STANDING INSTRUCTION NO: 339

SUB: Execution of outside plaster upto plinth level with cement mortar 1 : 4 (1 cement : 4 Coarse Sand) on houses/flats being constructed by DDA.

Sub:- OUT SIDE PLASTER OF HOUSING FLATS.

Details of External Wall Plaster

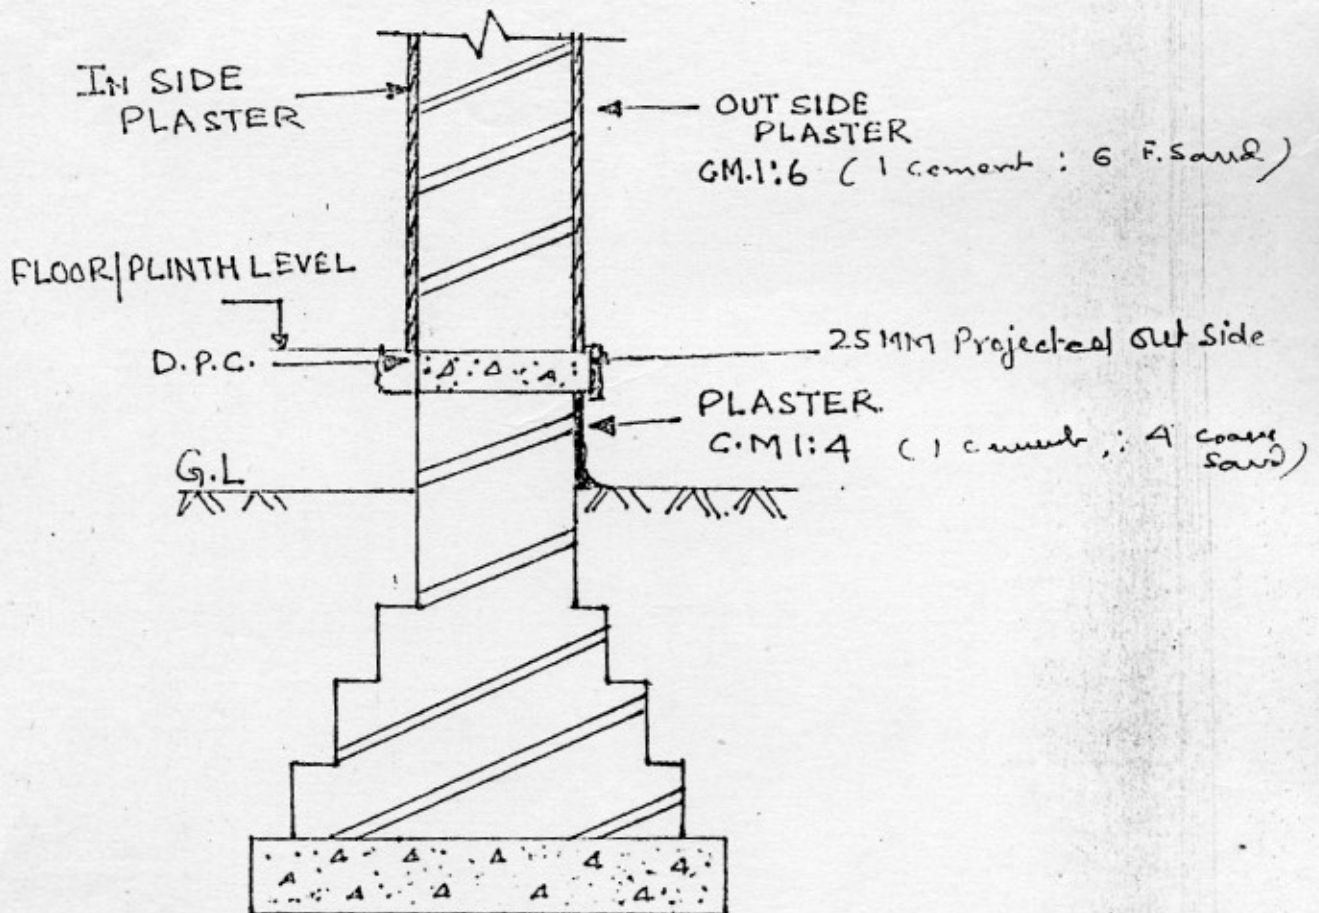
It has been observed in several housing pockets constructed by DDA in East, North & Rohini Zones that due to high subsoil water table in the areas, outside plaster starts peeling off after 2-3 years of construction, which gives a very ugly look to the flats.

In order to overcome this phenomenon, it has been decided that in all future contracts, specific provision may be made for outside plaster of houses with cement mortar 1 : 4 (1 cement : 4 Coarse sand) between plinth level & plinth protection level.

It has also been decided that DPC should project by 25 mm outside the wall surface as suggested by the Chief Architect. (as per sketch enclosed).

Method of plastering: Plastering of outside walls above DPC level shall be carried out as per item provided in the contract and the same shall be stopped at the top level of DPC.

The plaster from DPC upto plinth protection shall however, be carried out only after plinth protection has been laid so that the plaster which is provided from DPC level upto plinth protection does not show appearance of any joints between the plaster and the plinth protection & pounding done at the junction of plaster & plinth protection.
